Subject: FW: Docket ID NRC 2011-0022 Comments from the Electric Power Research Institute (EPRI)
Attachments: EPRI May 2012 BTP Comments.pdf

Subject: Docket ID NRC 2011-0022 Revised Branch Technical Position on Concentration Averaging and Encapsulation of Low-Level Radioactive Waste.

The purpose of this letter is summarize some of the technical conclusions from EPRI low-level waste (LLW) research and to identify areas for improvements in the May 2012 draft revision of the BTP (U.S. Nuclear Regulatory Commission, 2012).

Chart 1

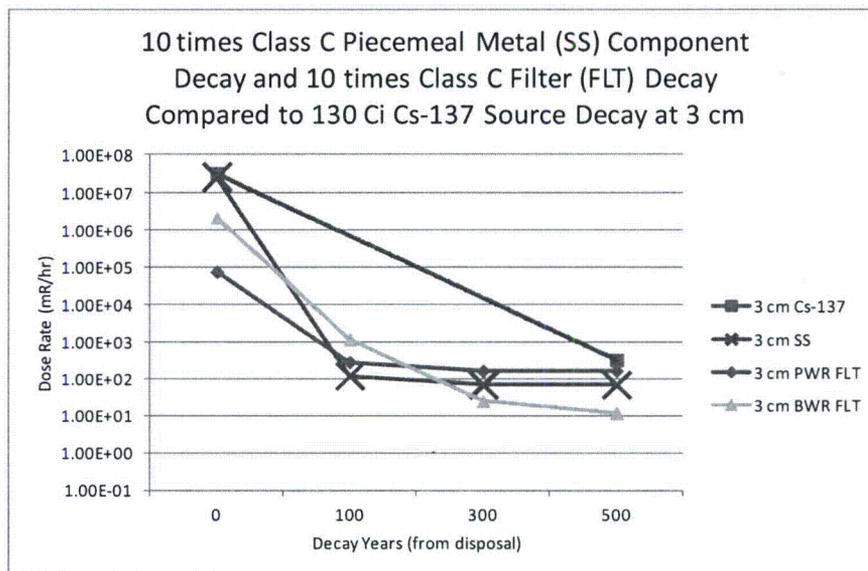
Chart 1 demonstrates that cartridge filters and discrete pieces of activated metal which were ten times Class C when disposed would exhibit 3 cm dose rates lower than a 130 Ci Cs-137 source at 500 years.

Chart 2

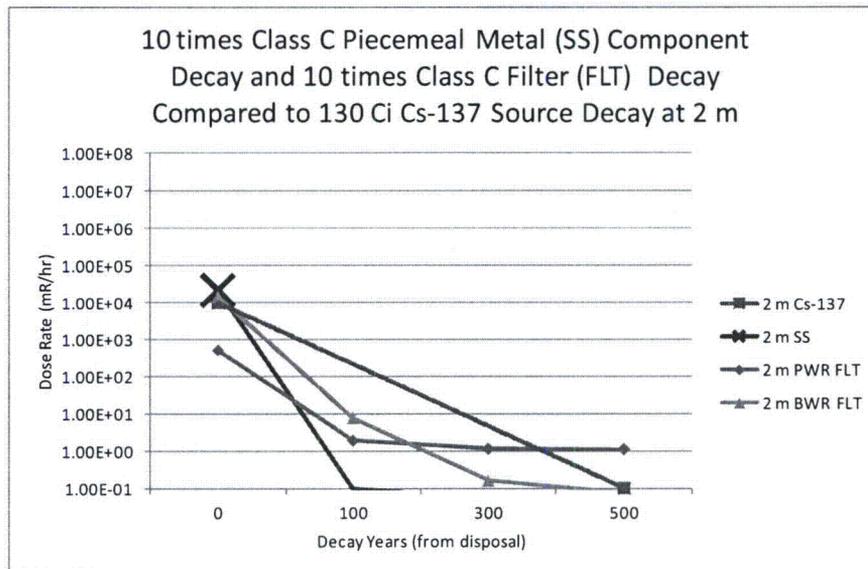
Chart 2 demonstrates that cartridge filters and discrete pieces of activated metal which were ten times Class C limit when disposed would exhibit 2 m dose rates of 1 mR/hr or less at 500 years, which is essentially equivalent to the risk of a 130 Ci Cs-137 source at 500 years given all the other uncertainties in the intrusion scenario.
